**LEBANON PLANNING BOARD
MARCH 18, 2024 - 6:30 PM
COUNCIL CHAMBERS, CITY HALL OR
REMOTE VIA VIRTUAL PLATFORM
LEBANONNH.GOV/LIVE**

CITY OF LEBANON ~ PLANNING & DEVELOPMENT

Staff Memorandum – PB2024-02-CUP – *con't from 1/29/24*

Site Plan Review for a conversion of the existing two-family dwelling to a mixed-use building for a proposed office use and a dwelling unit, together with associated site improvements

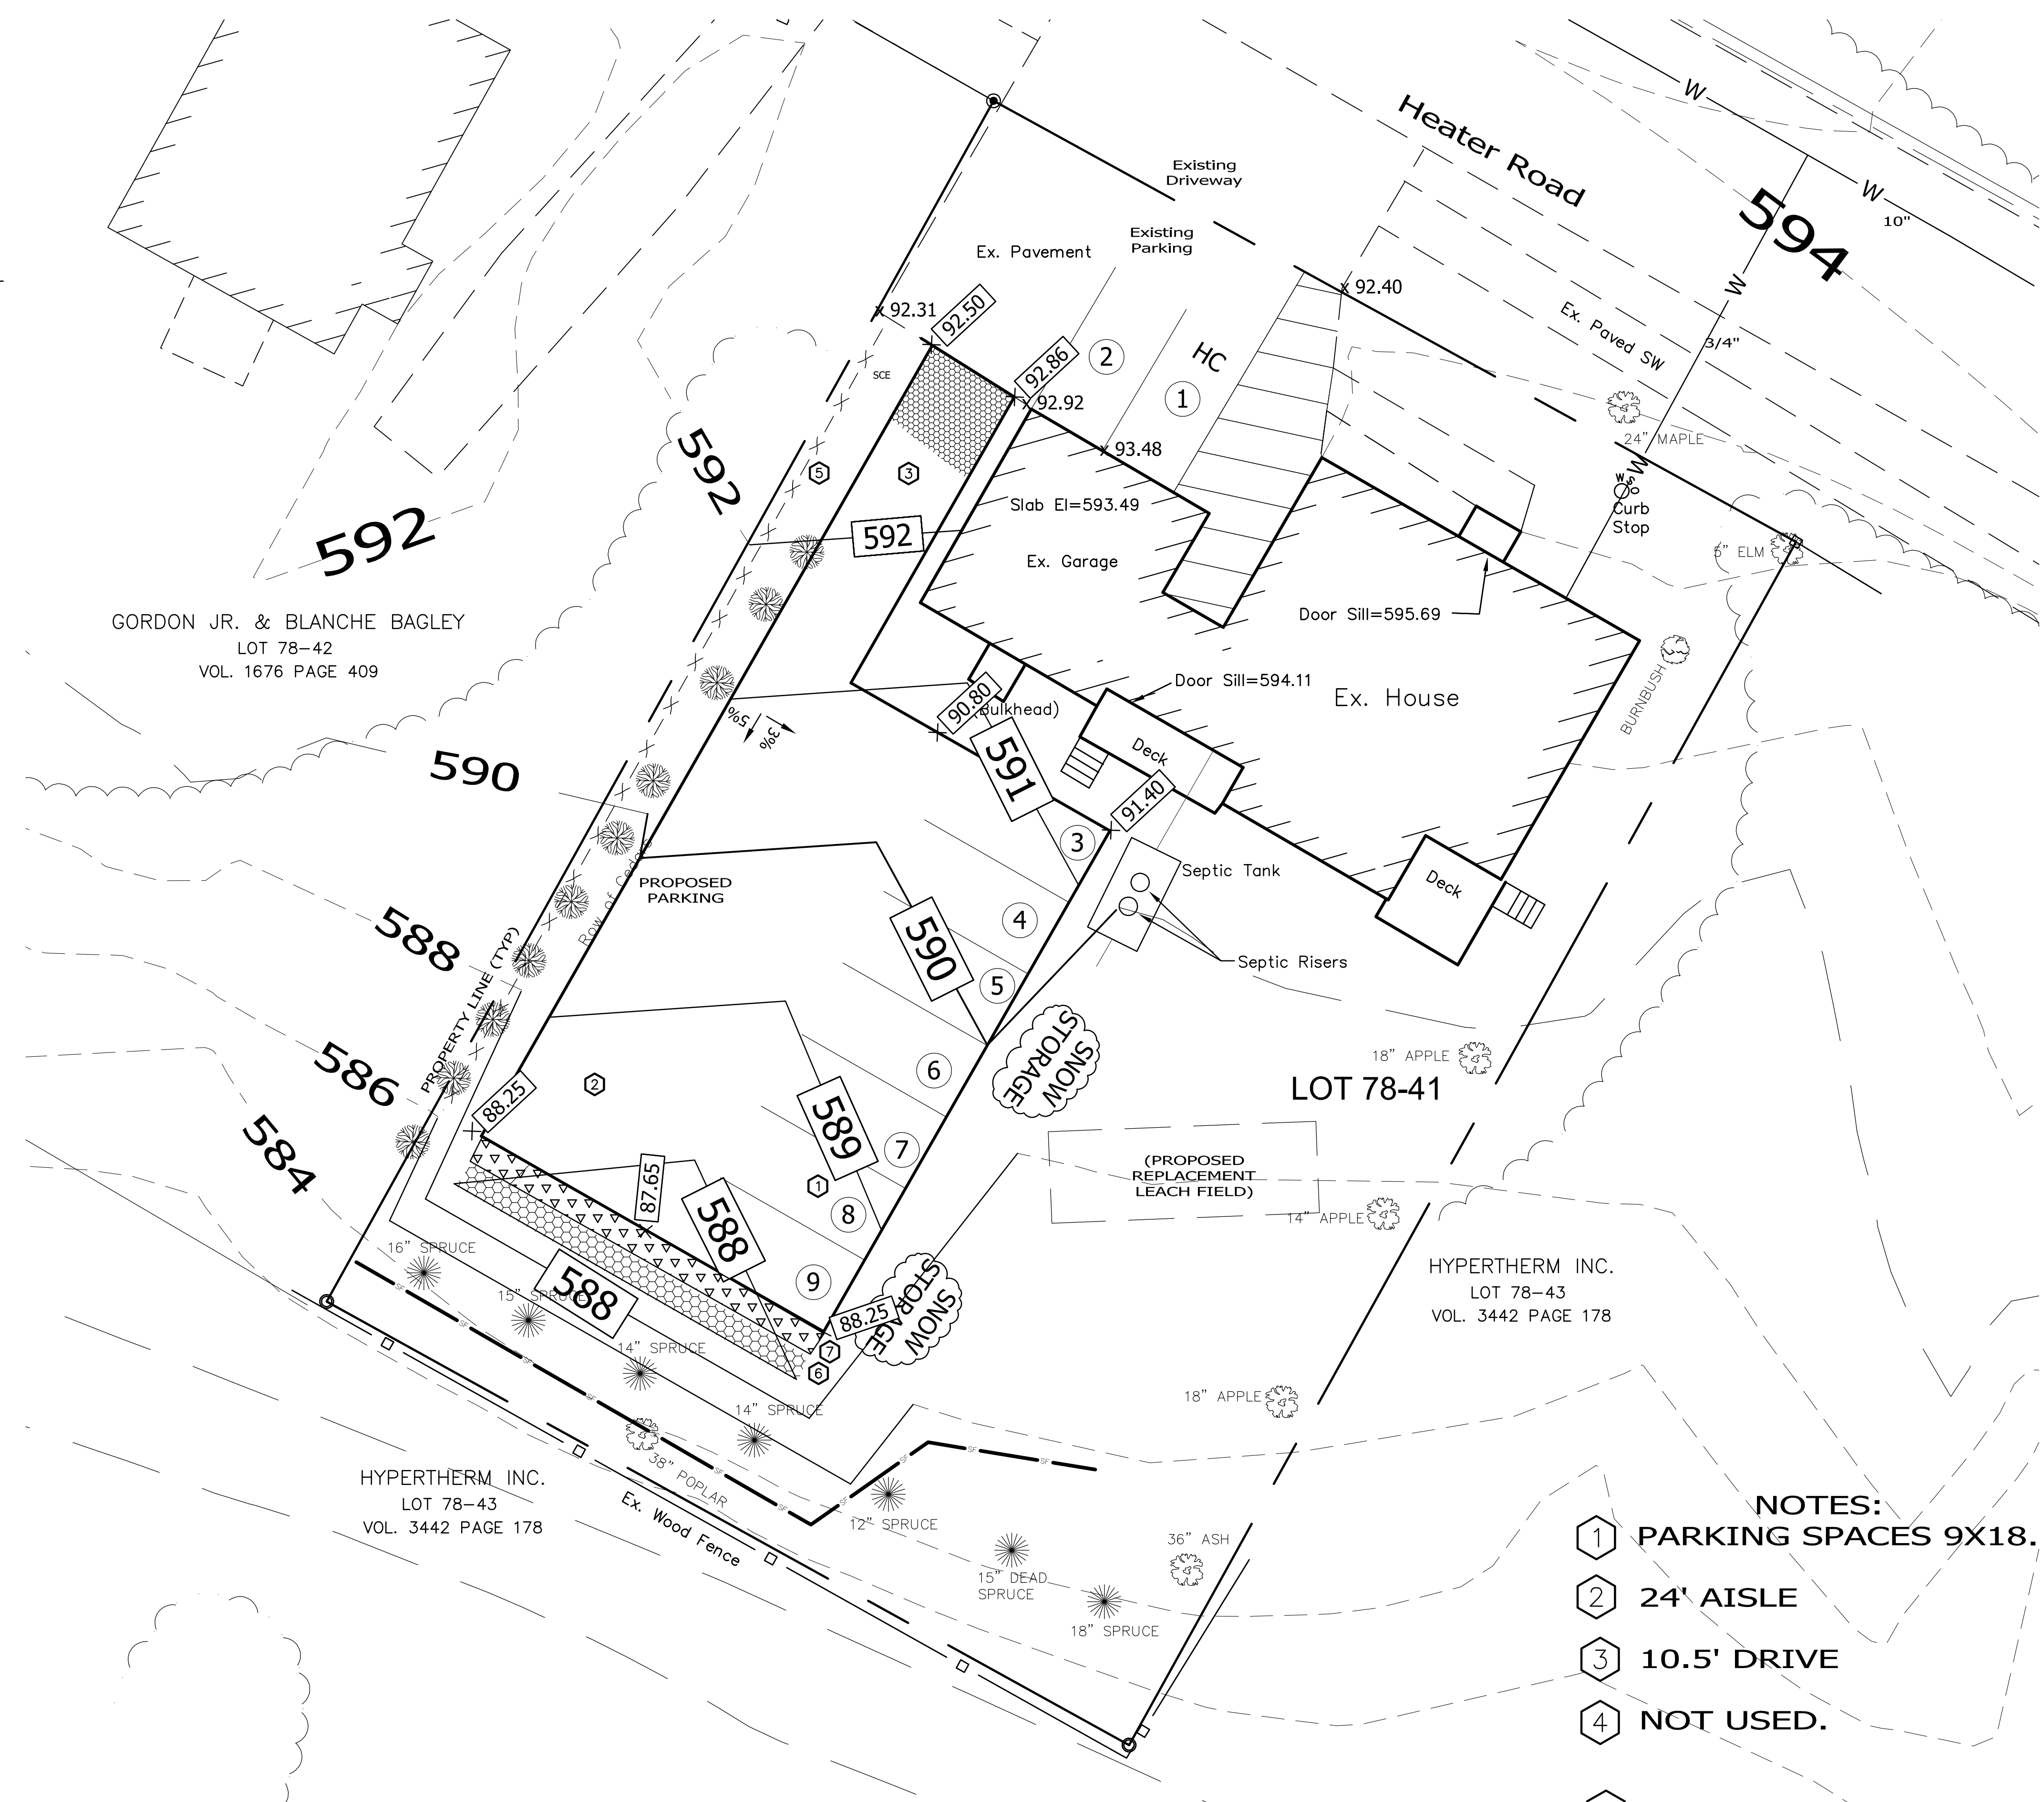
- Sheets “C-1” and “C-3” of the plan set are identical except that Sheet C-3 provides a design detail and a brief legend. Was this a mistake or intentional? If intentional, what is the purpose of having two identical plan sheets?

- On the site plan (Sheet "C-1"), staff had requested that the applicant:
 - provide a legend identifying various symbology.
 - identify proposed uses of the existing building (instead of "ex. Garage" and "ex house" which would be more appropriate for an existing conditions plan, not a site plan that is intended to depict future conditions).

G. Sheet C-1

1. Existing contours removed.
2. Erosion Control legend added. See Sheet C-3
3. Proposed Use. Proposed use is listed on Cover sheet. It is good engineering practice to indicate existing as well as proposed items on plans.
4. Topo. PE stamp is on Sheet C-1 depicting topography. Except under proposed parking, where staff directed it be removed.
5. Drive aisle. Aisle width reduced.
6. Ramp. Ramp removed.
